E. R. Squibb & Sons, Inc.

This is in response to your letter of February 18, 1982 in which you requested additional information with respect to Squibb's Radiological Contingency Plan. Each of your comments have been addressed in the enclosure. Also included are additional or replacement pages for the required information.

Response to Comments on Squibb's Radiological Contingency Plan

DRAWING TITLE
SCHEMATIC FLOW DIAGRAMS

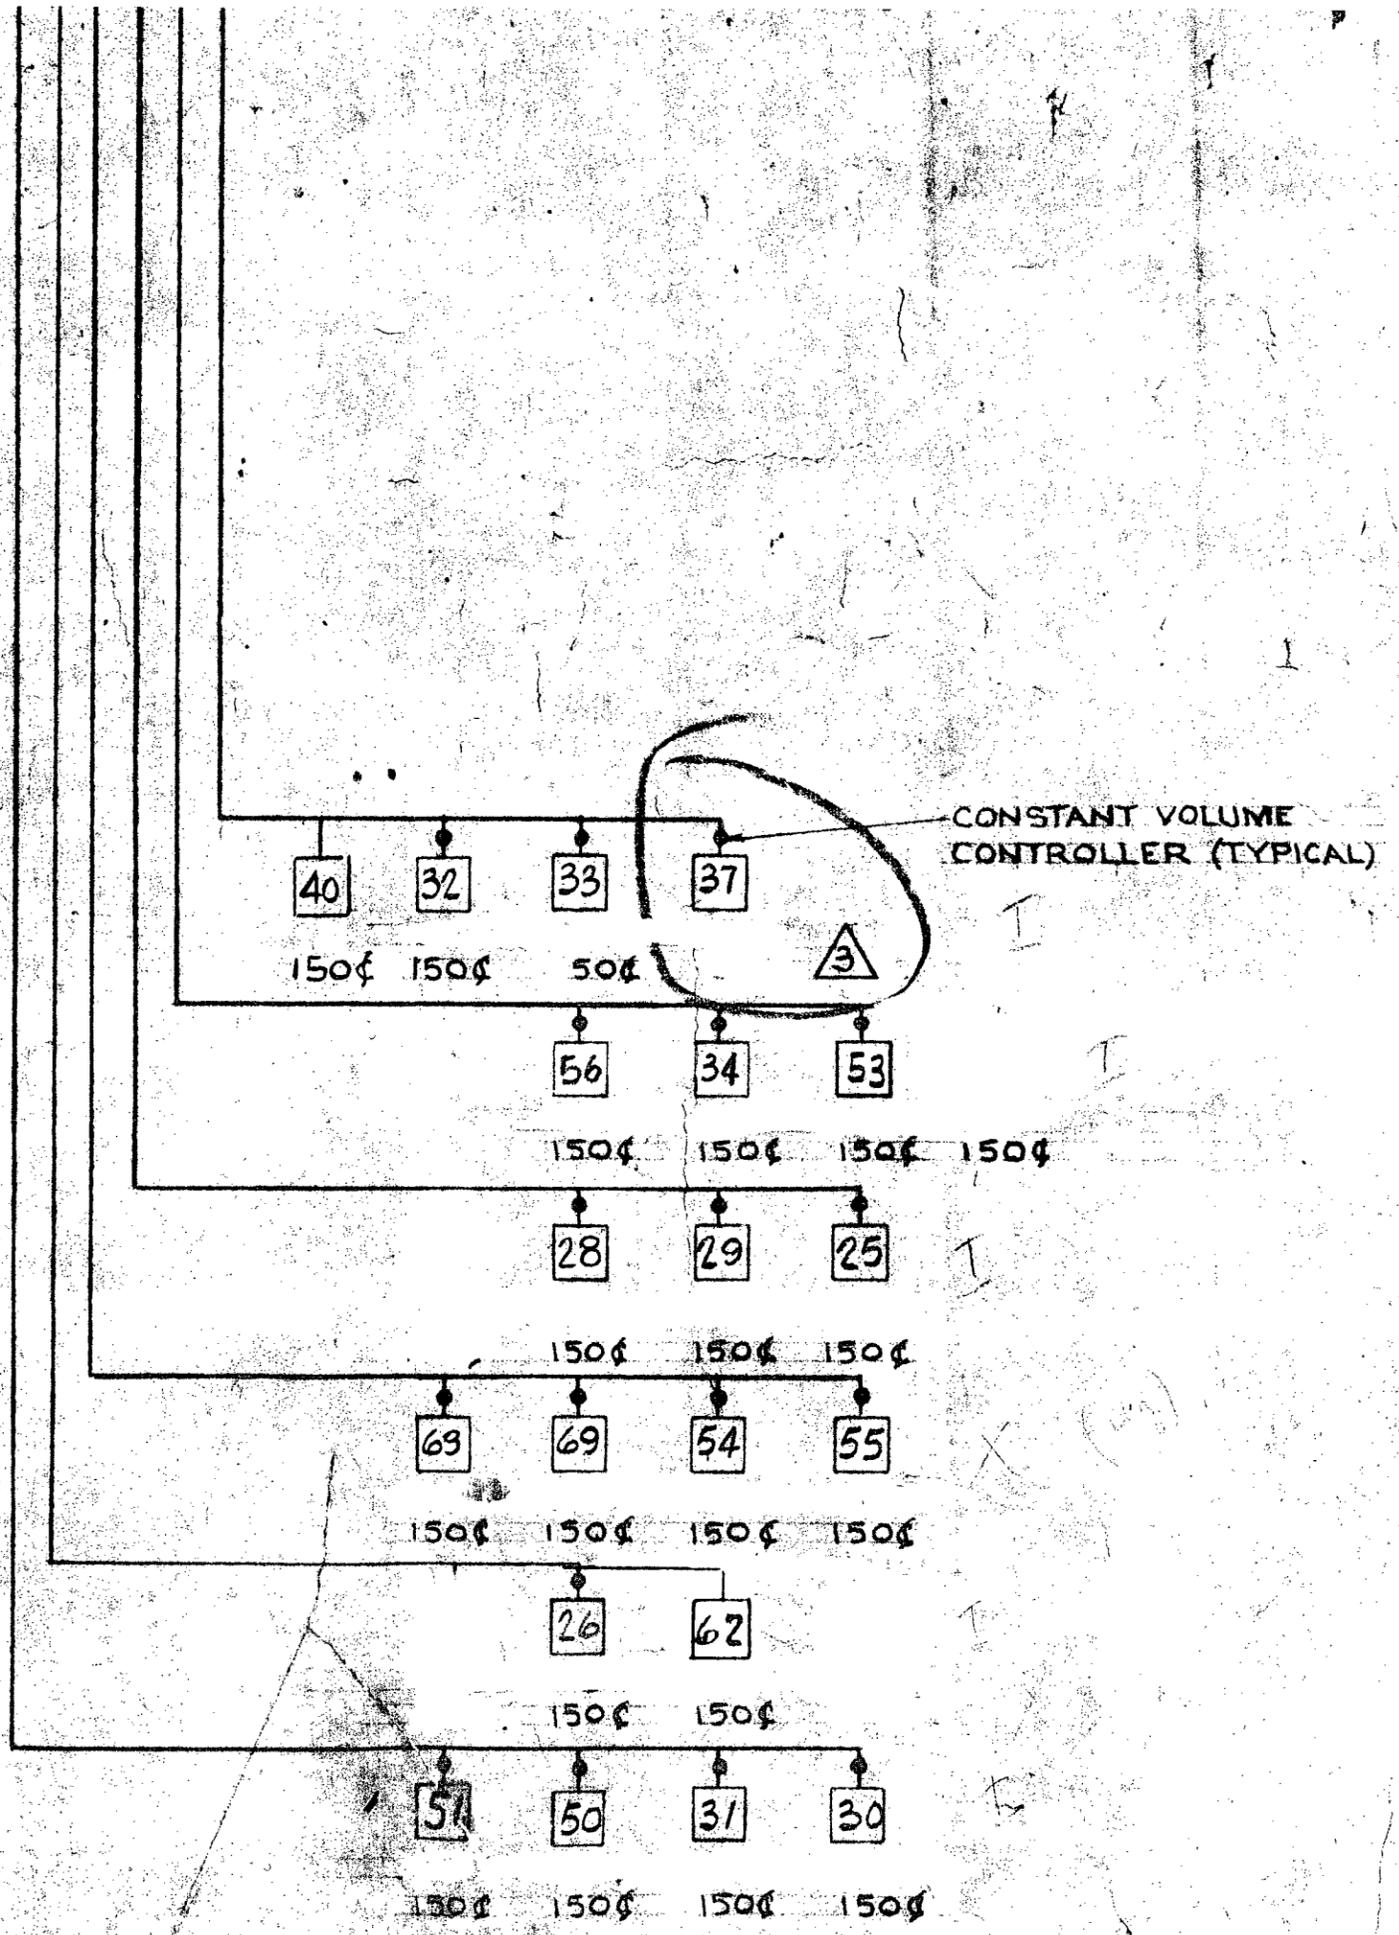
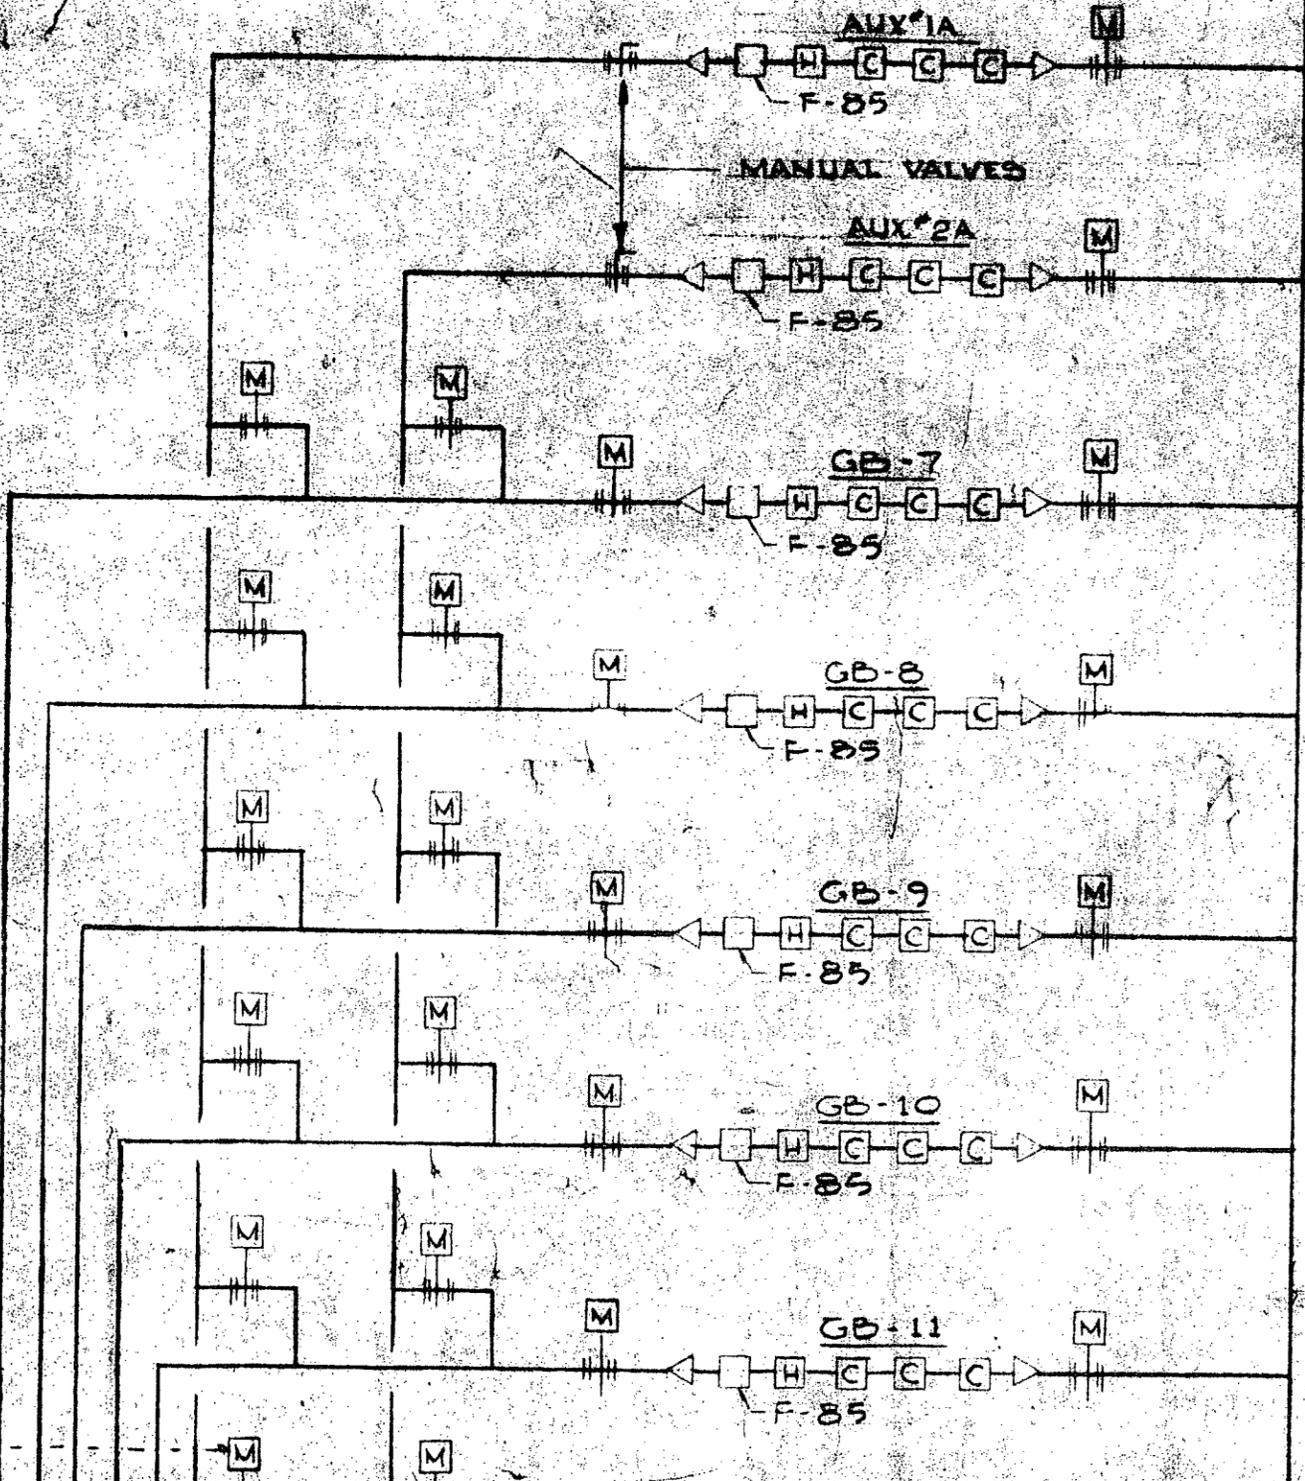
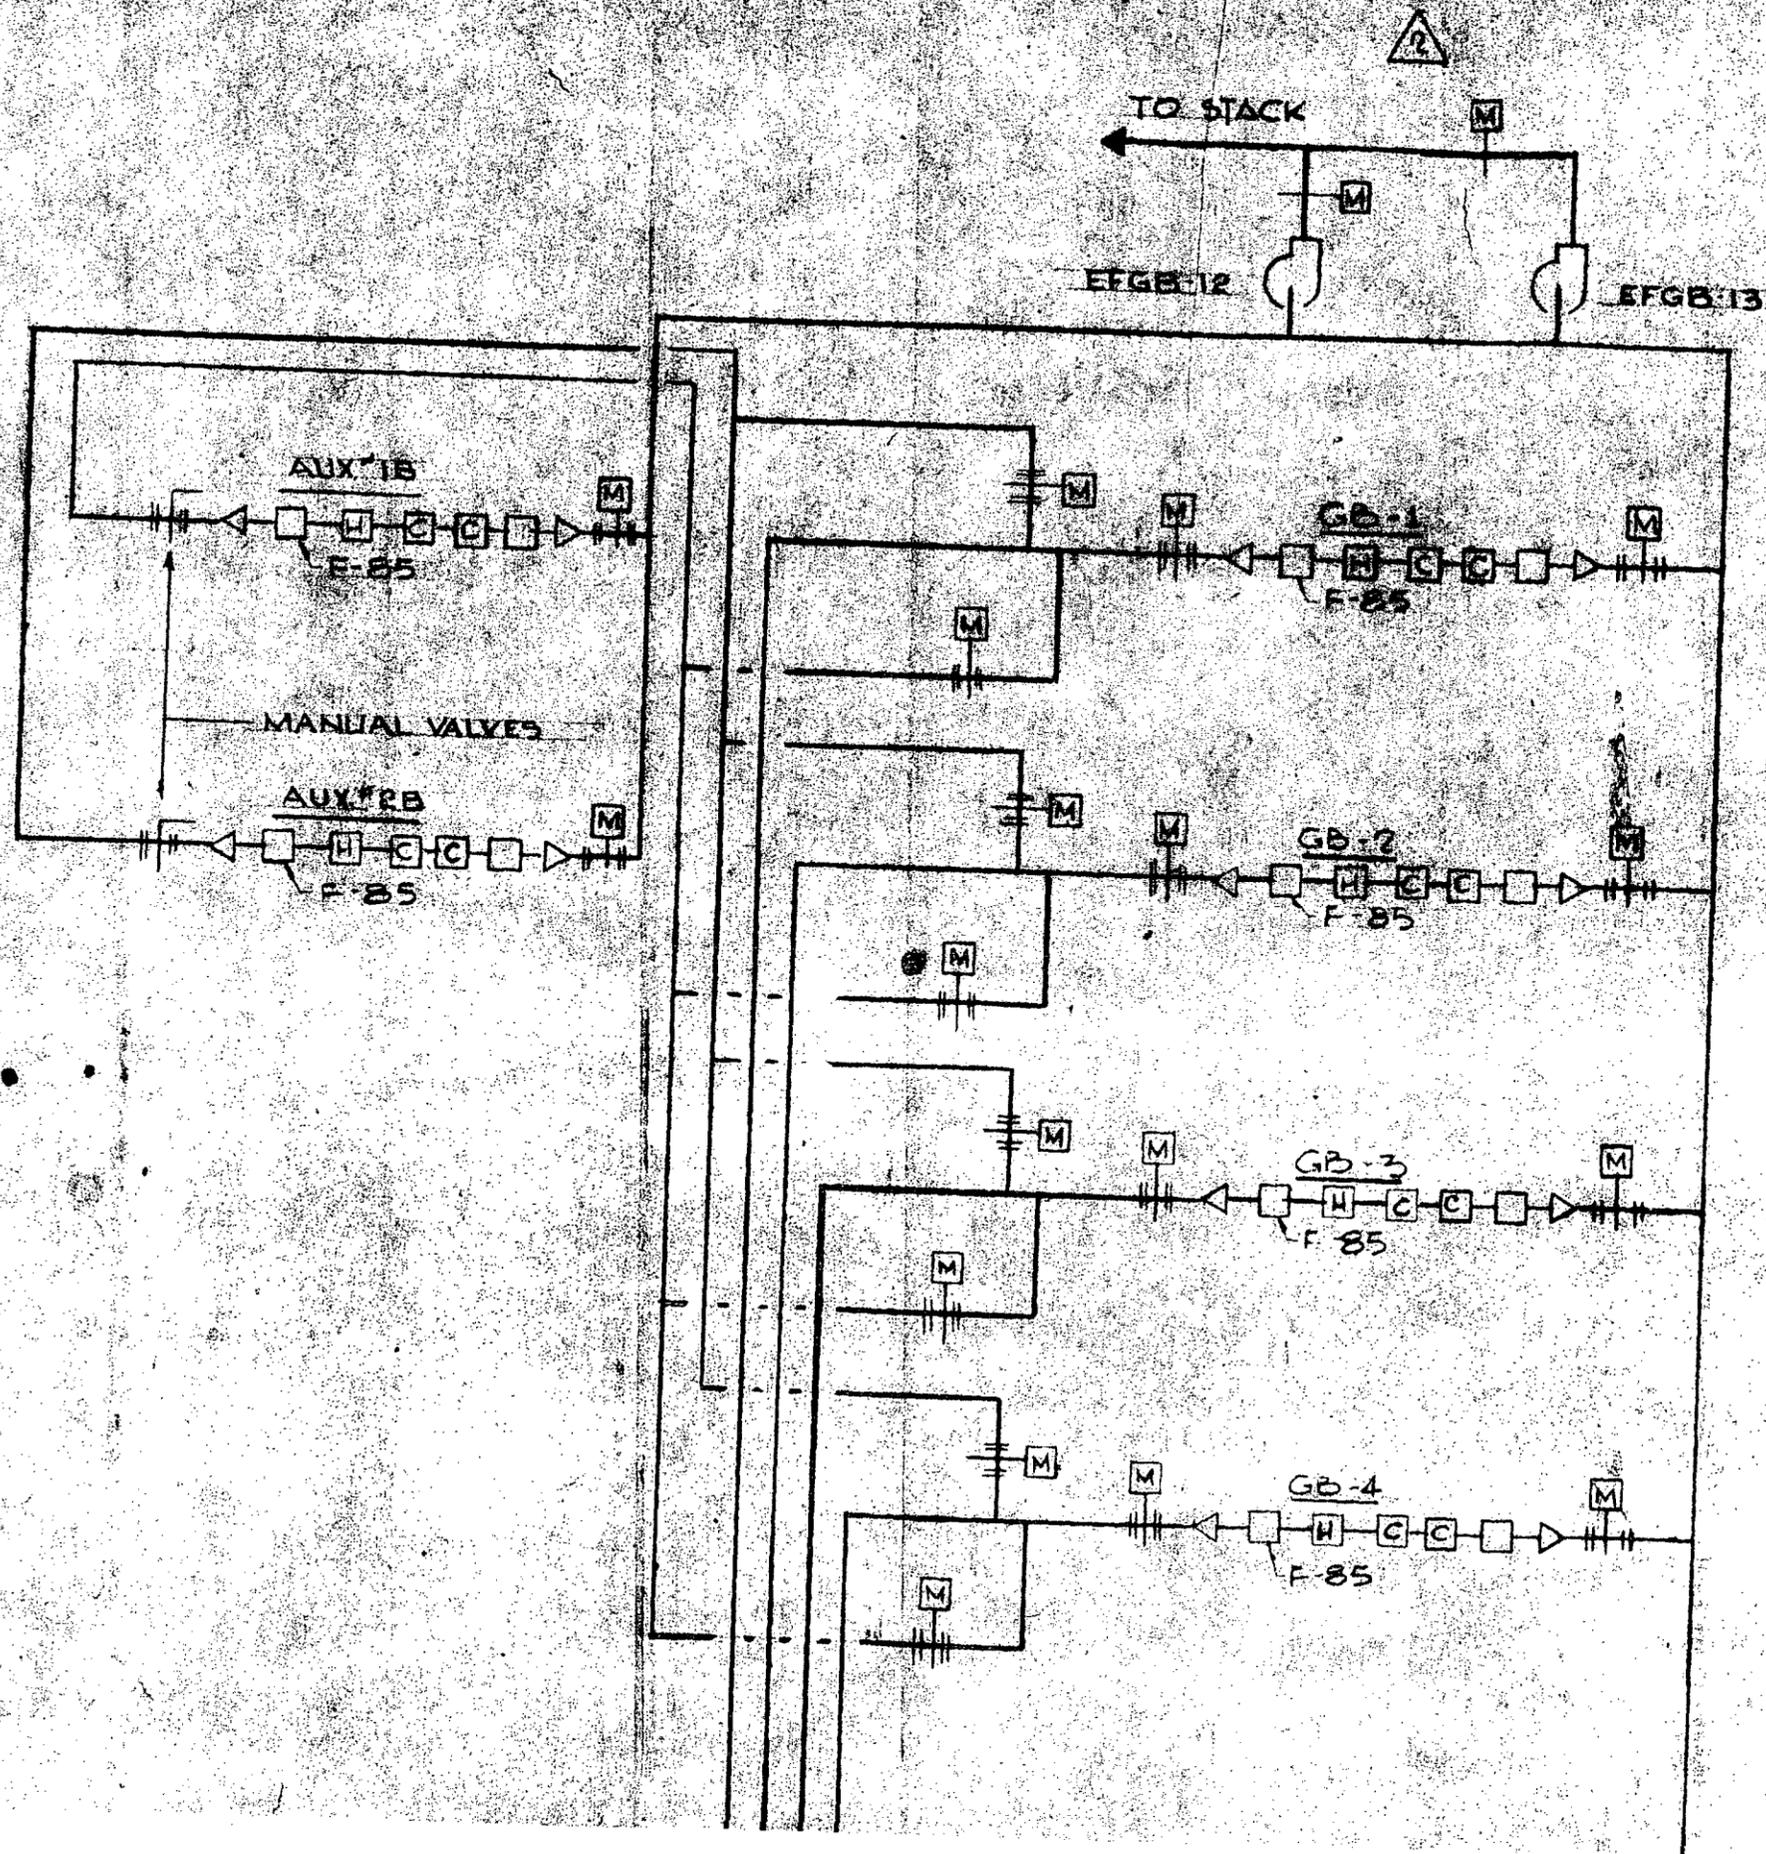
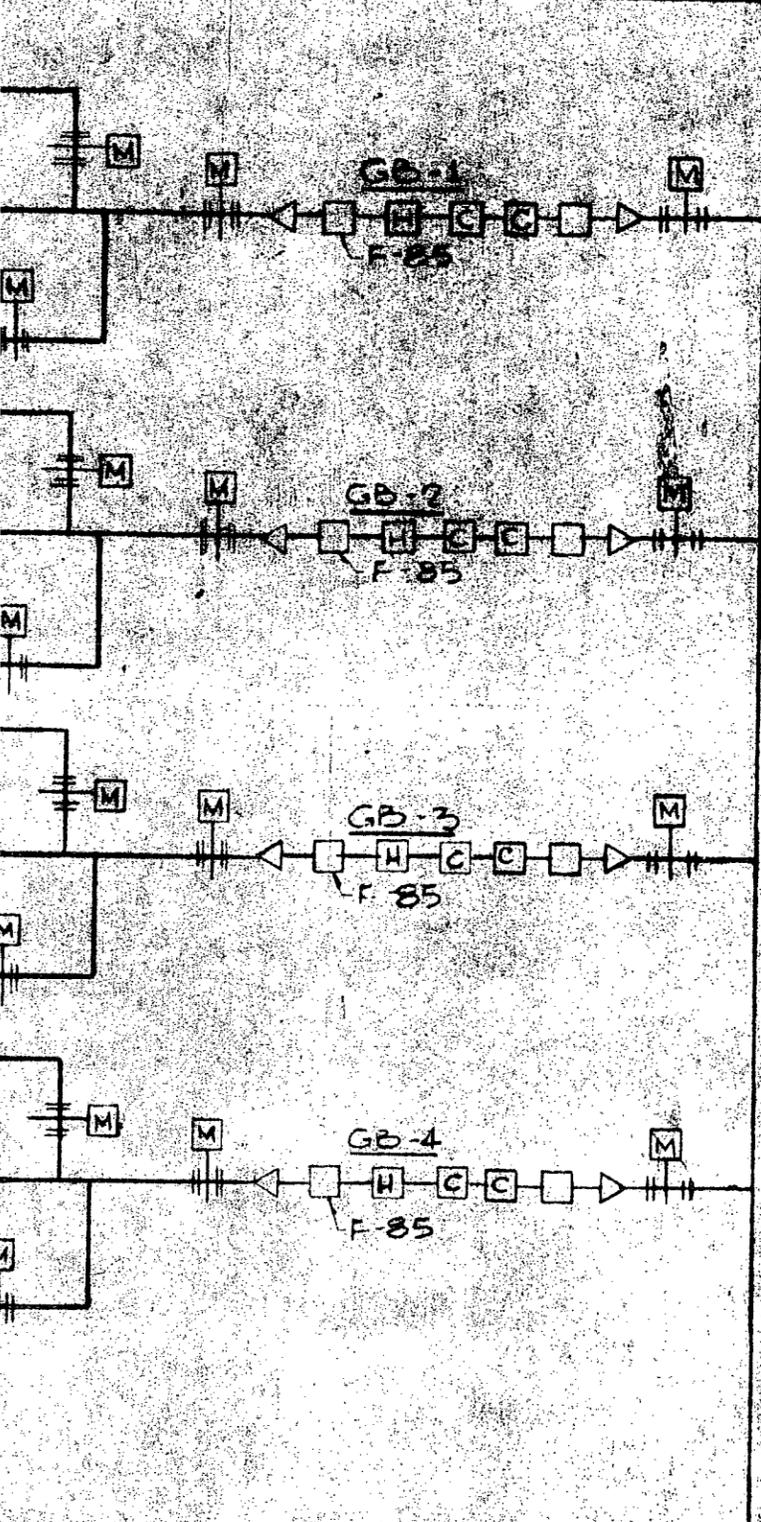
Schematic drawings showing the relationships among the glove boxes, fume hoods, hot cells and filter banks with associated ducting have been referenced in this section.

These drawings have been added as an addendum to the plan.
